REQUEST FOR ADDITIONAL INFORMATION - HCGS PUAR
HOPE CREEK GENERATING STATION
DOCKET NO. 50-354

HOPE CREEK GENERATING STATION

PLANT UNIQUE ANALYSIS REPORT

ADDITIONAL INFORMATION ON HYDRODYNAMIC LOADS FOR NRC REVIEW

Figure 2-1

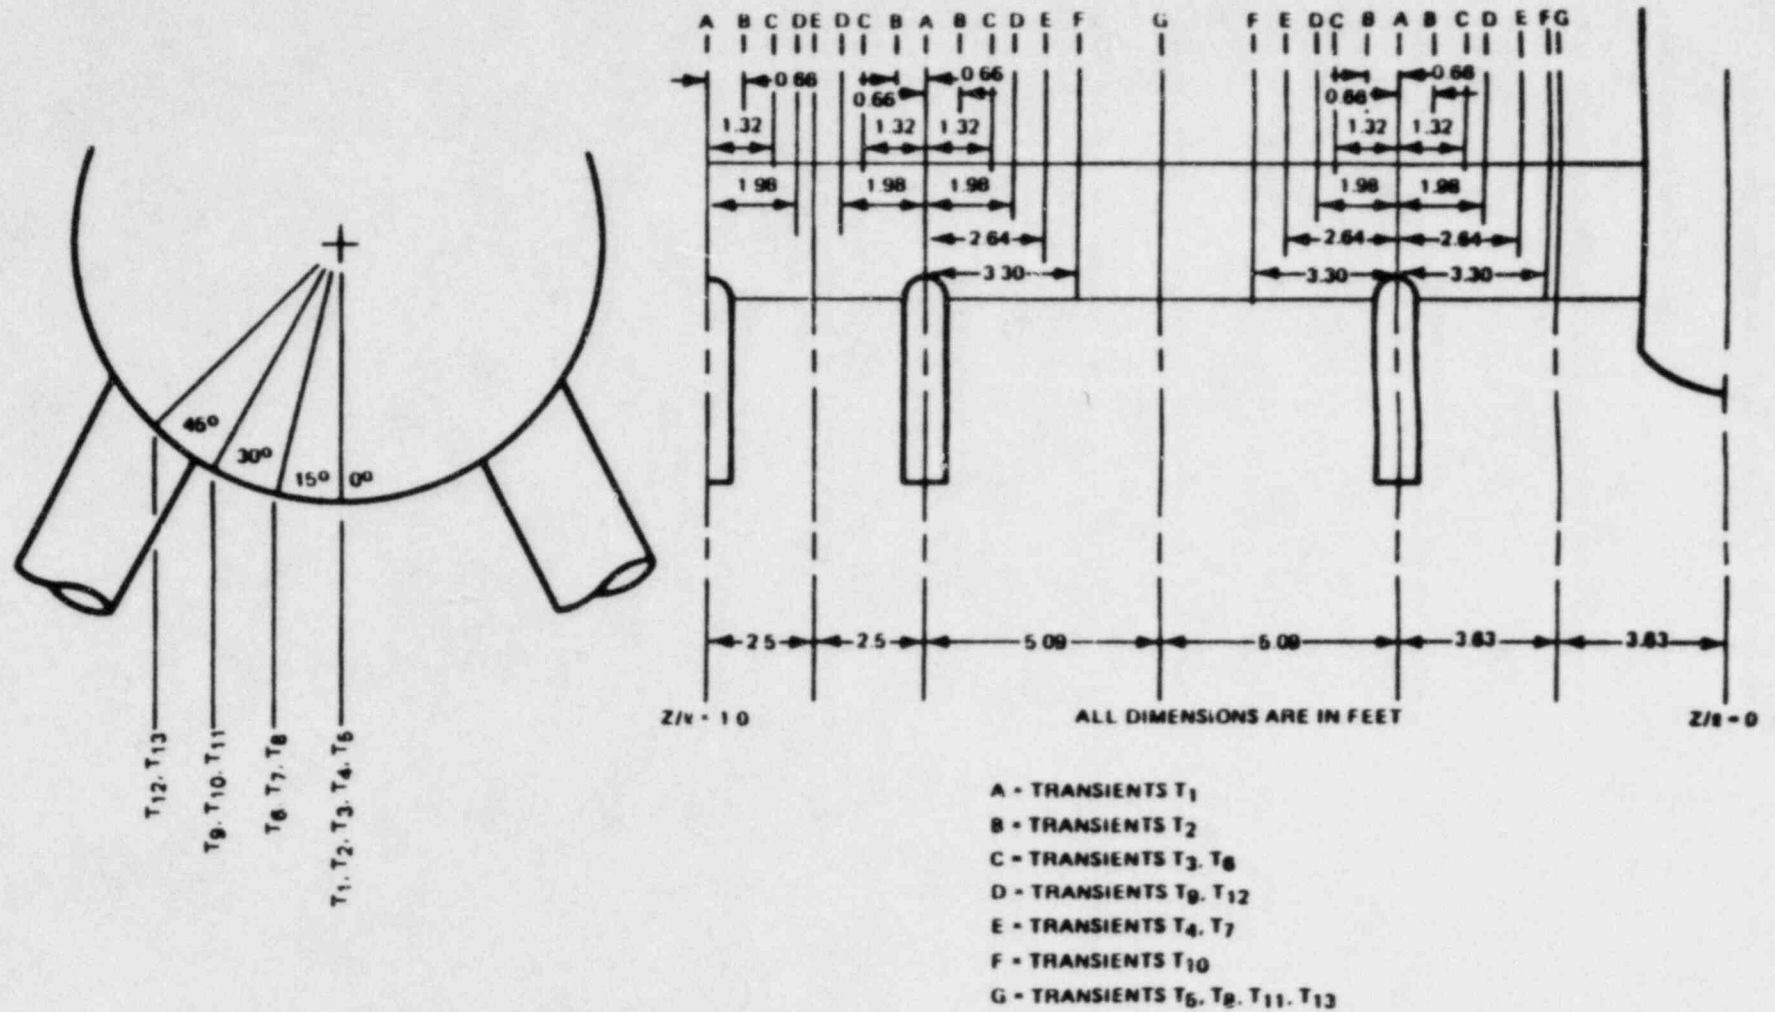
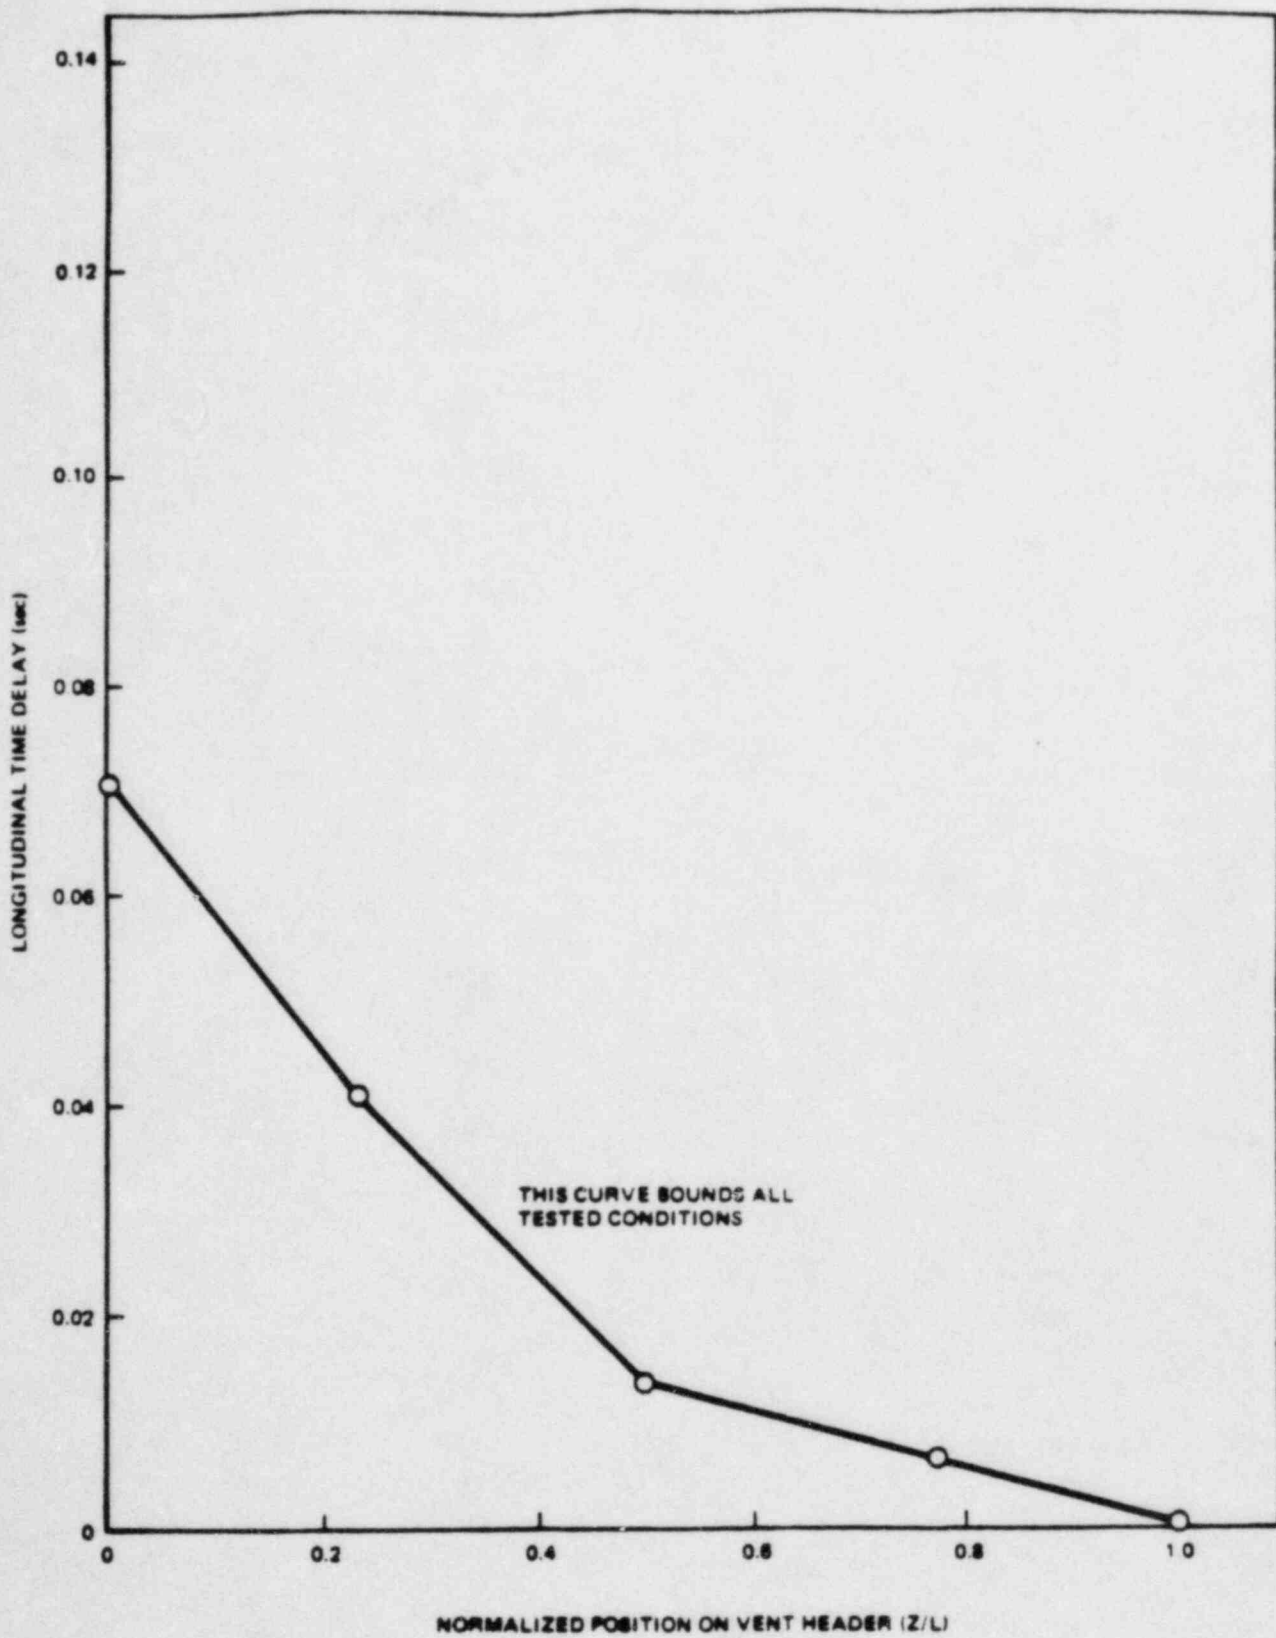
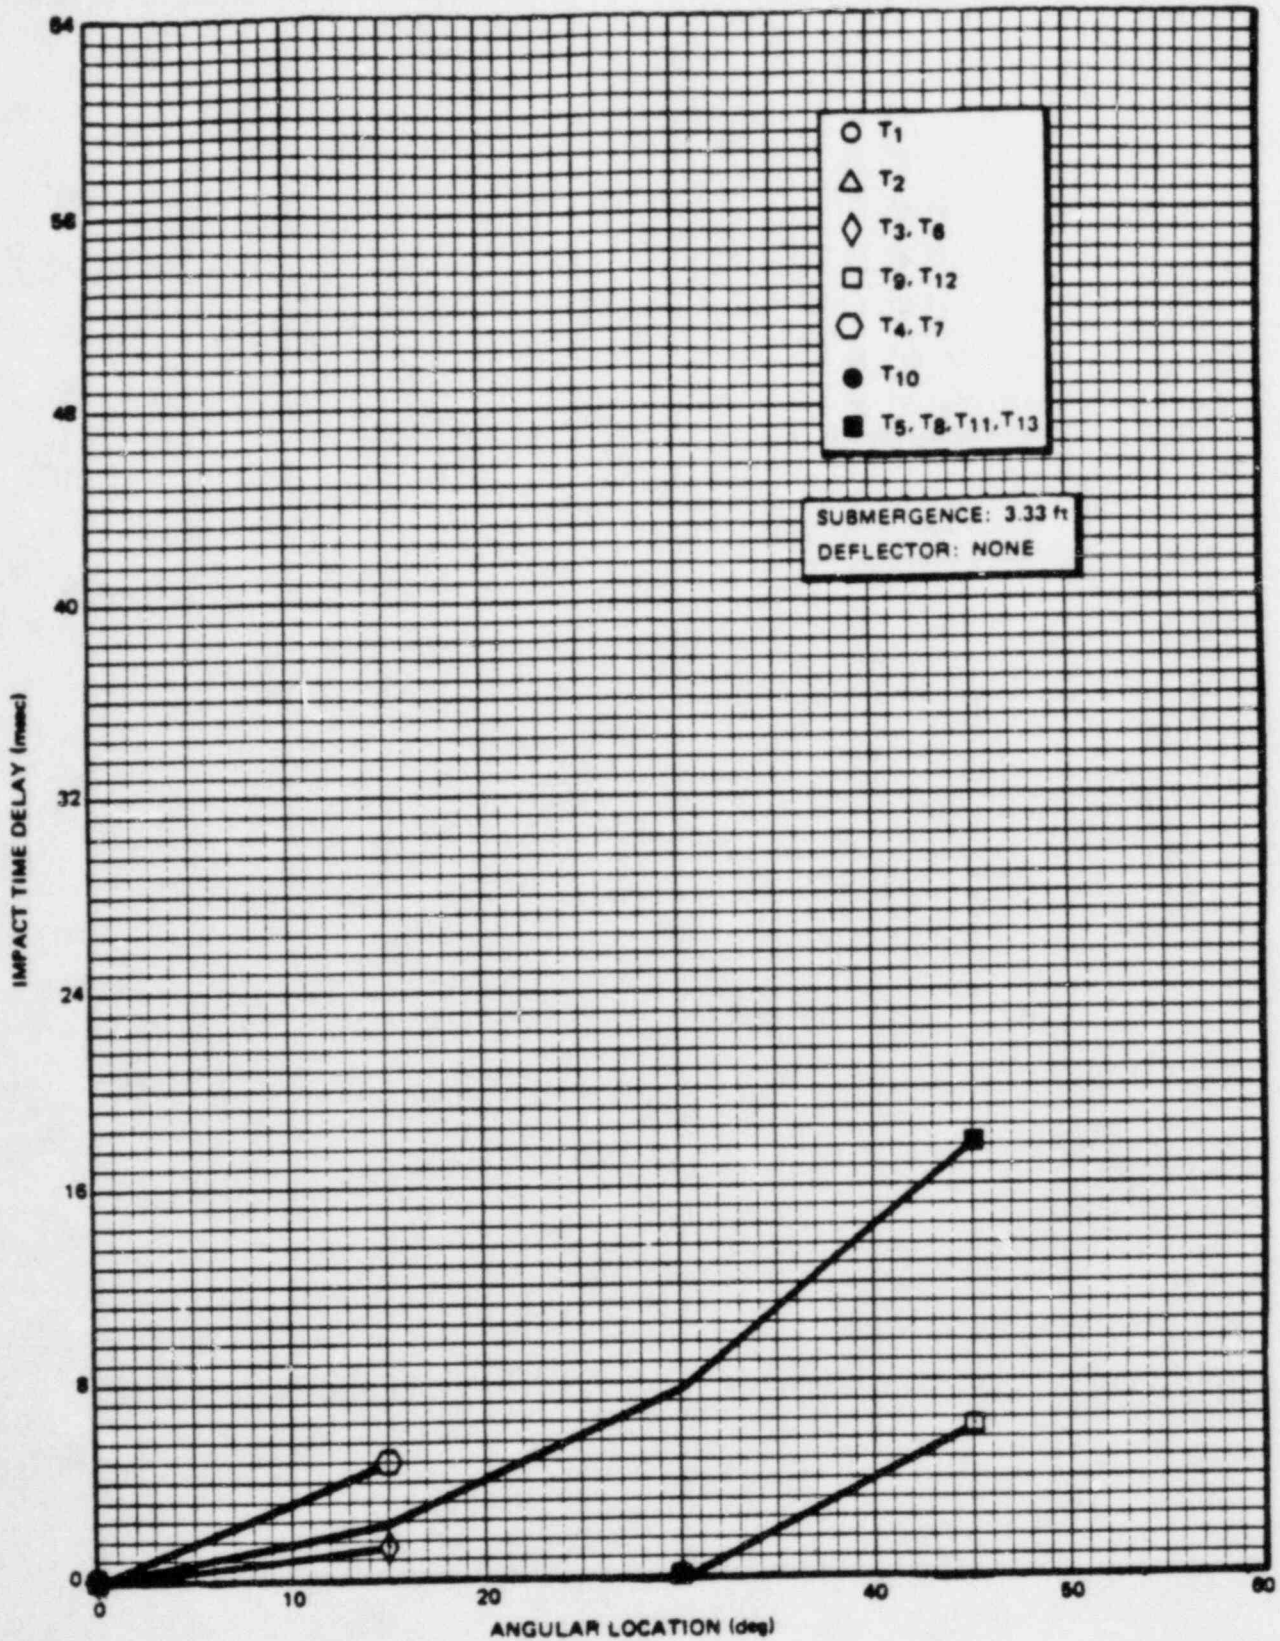
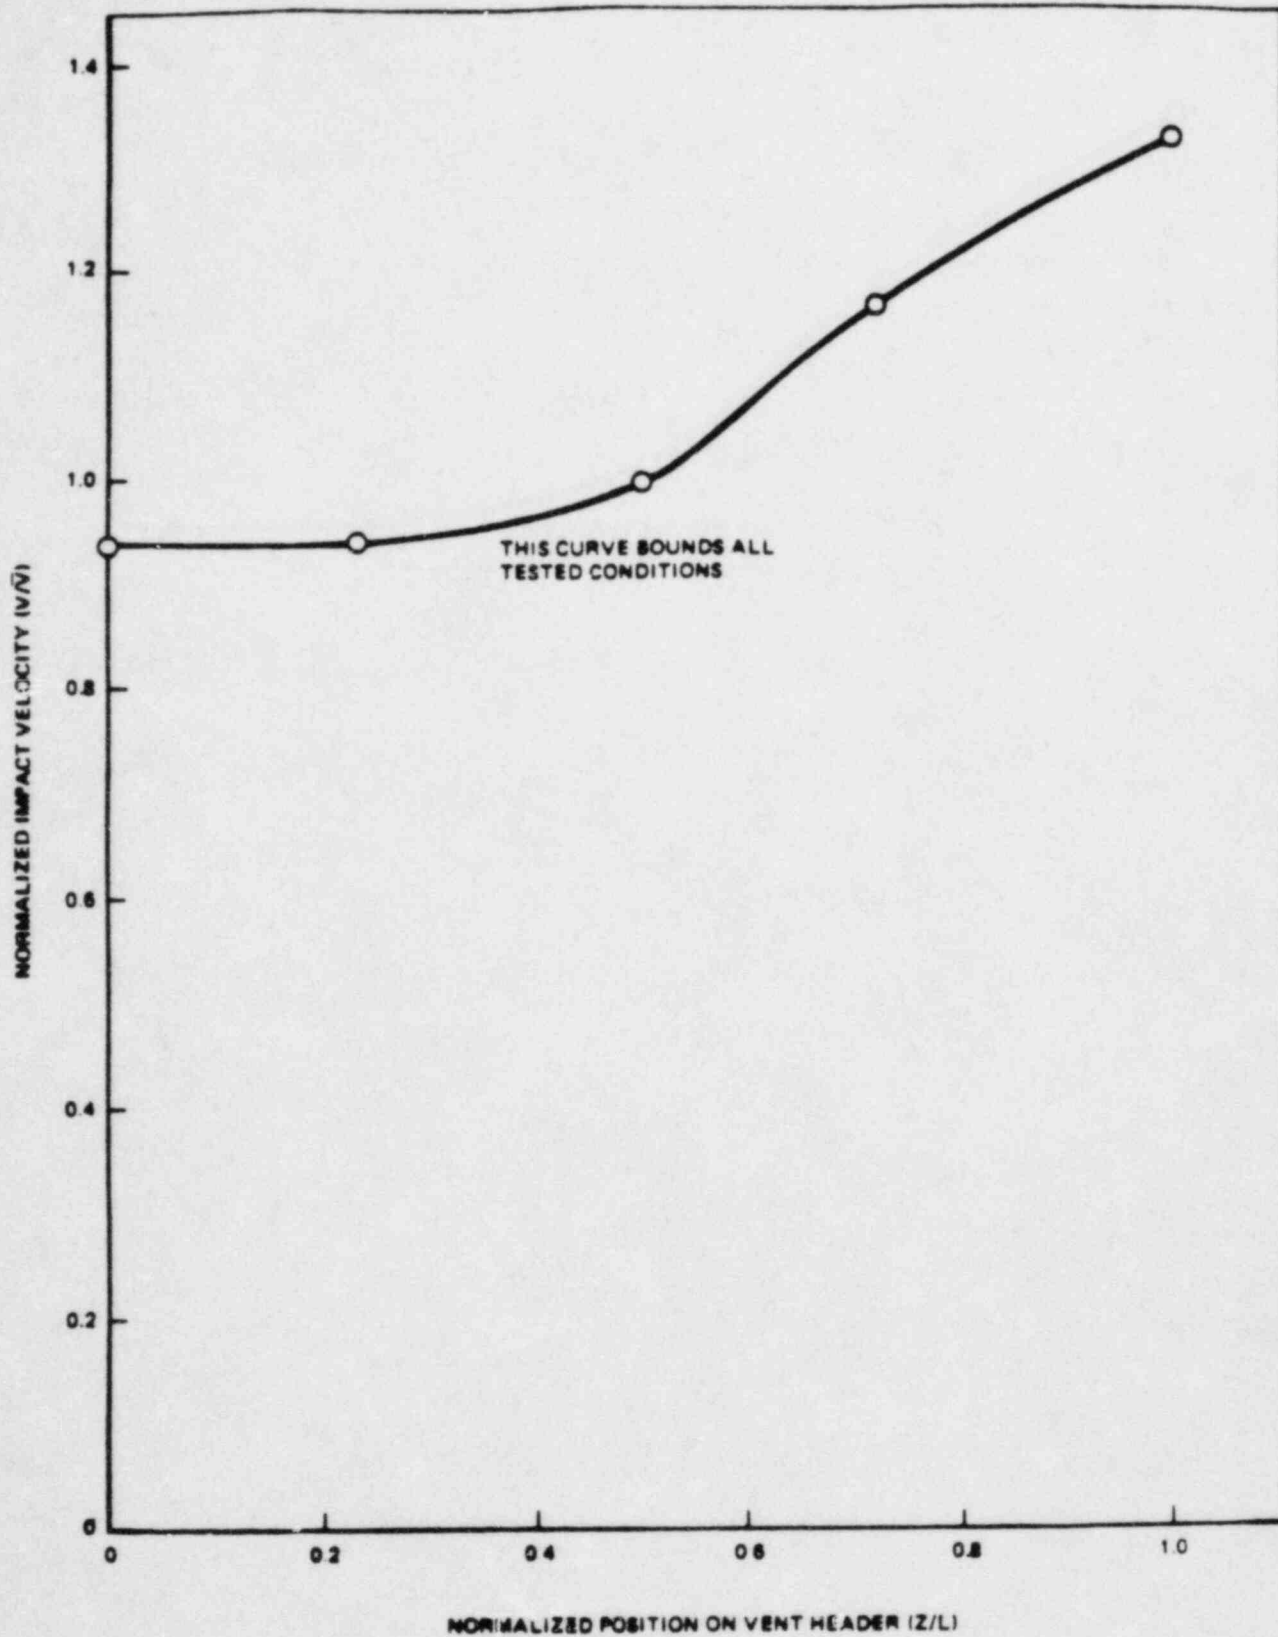
ITEM 2: Hope Creek does not use a vent header deflector. Provide details of the vent header pool swell impact load calculation for Hope Creek.

The procedure described in Section 3.5.1.1 of NUREG-0661 was used to evaluate the pool swell impact loads on the vent header. As Hope Creek does not have a vent-header deflector, the vent header is directly impacted by the pool swell. Hope Creek Plant Unique Load Definition (PULD) report provides the pool swell impact pressure transients on the vent header as a function of position and time. Figure 2-1 provides the locations where the pressure transients on the vent header were obtained from the QSTF plant-unique tests.

Pool swell first impacts at the midcylinder (longitudinal location parameter $Z/l=1.0$) and then travels towards the vent line in the other bay ($Z/l=0.0$). The plant unique vent header impact timing, i.e., longitudinal and circumferential time delays from PULD are shown in Figures 2-2 and 2-3. As per NUREG-0661, the longitudinal time delays are based on EPRI Main Vent Orifice Test while circumferential time delays are based on QSTF generic test series.

In order to calculate pressure time histories at the 1/16th vent system model nodes, interpolation from locations shown in Figure 2-1 was performed along the longitudinal and circumferential direction taking into account the time delays in Figures 2-2 and 2-3.

Longitudinal vent header impact normalized velocity distribution based on EPRI Main Vent Orifice Test is shown in Figure 2-4 (from PULD). Since pressure is proportional to the square of velocity, the pressure values in PULD were multiplied by the square of normalized velocity at each node corresponding to the normalized position of that node on the vent header.

Figure 8-1

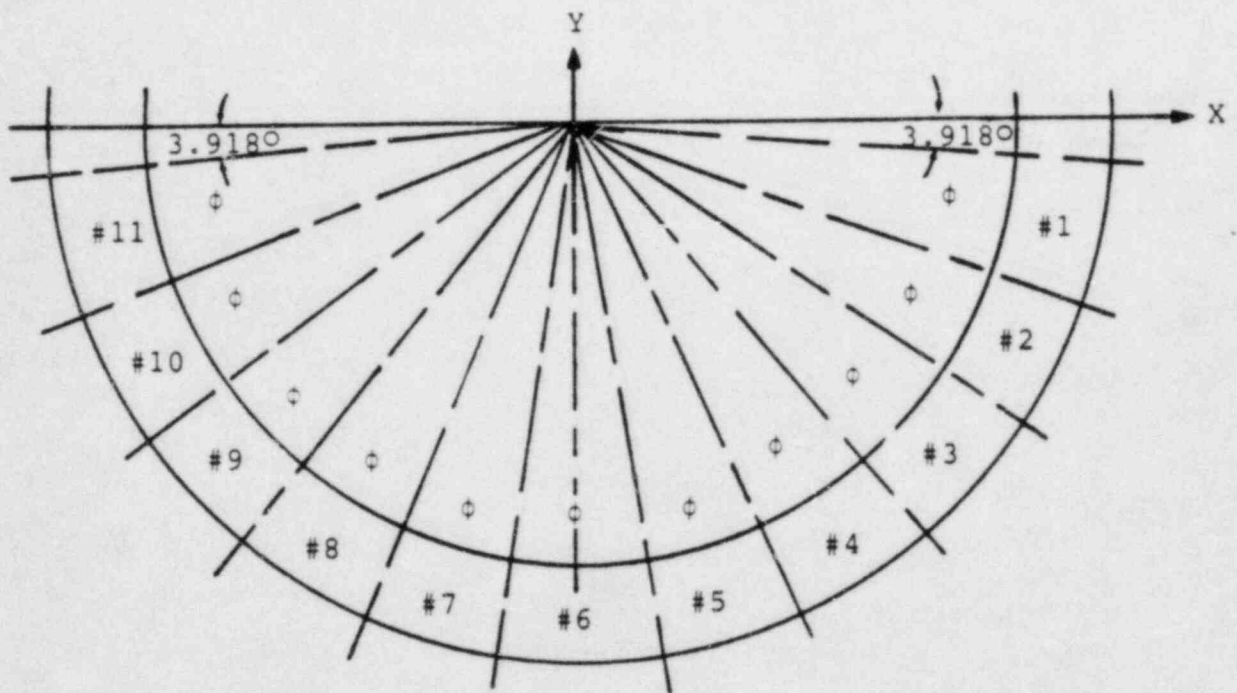
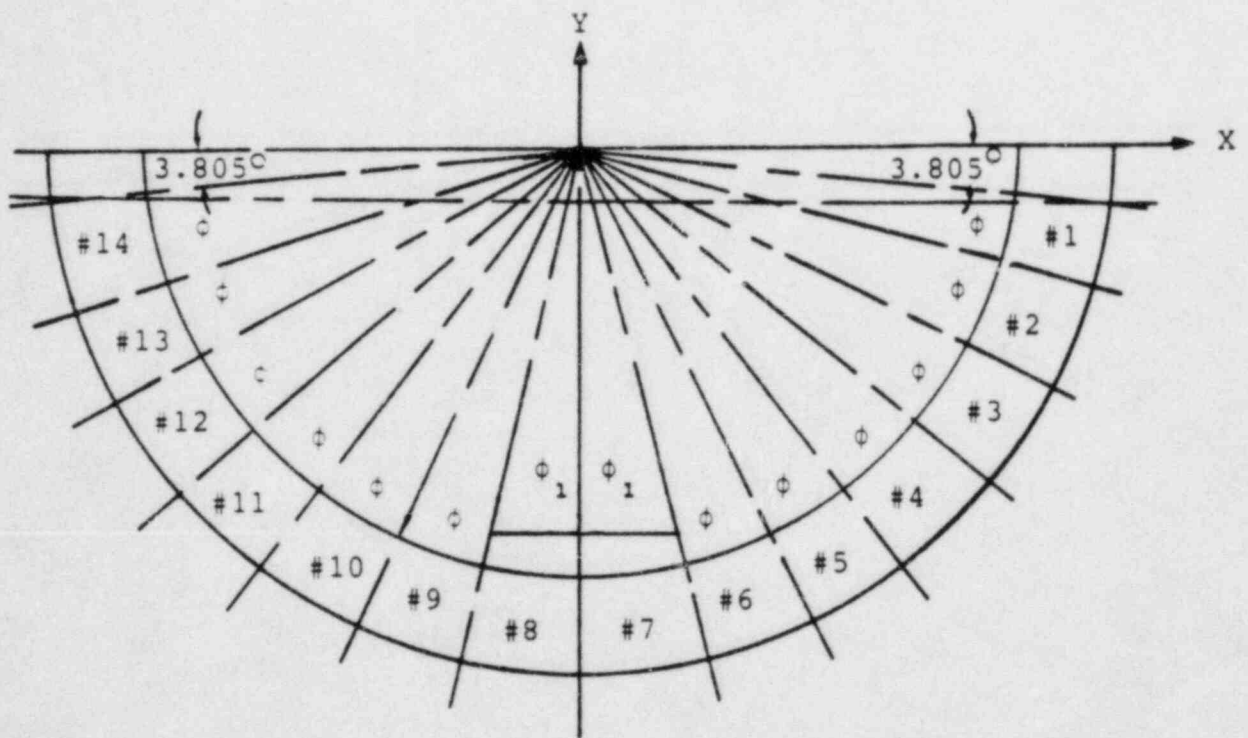
ITEM 8: The Hope Creek PUAR states that acceleration drag volumes for structures with sharp corners, such as I-beams, are computed using Table 1-4.1-1 when submerged structure drag loads due to pool swell, CO, chugging and SRV actuation are calculated. Since direct use of Table 1-4.1-1 is not possible for the ring girders, the specific formulas and acceleration volume values used for the ring girders are needed. Provide details of the acceleration volume calculation for drag loads in direction normal to the flange, web and stiffeners, respectively, for both the mitered joint and midcylinder ring beams. Provide final values of acceleration drag volumes in each direction for two or three segments of each beam.

For the purpose of calculating submerged structure loads on the ring girders, midcylinder and miter ring girders were divided into 11 and 14 segments as shown in Figures 8-1 and 8-2. The geometry of the ring girders and the models used to calculate the acceleration drag volumes for the in-plane and out-of-plane (normal to web) directions for the midcylinder and miter ring girders are shown in Figures 8-3 and 8-4.
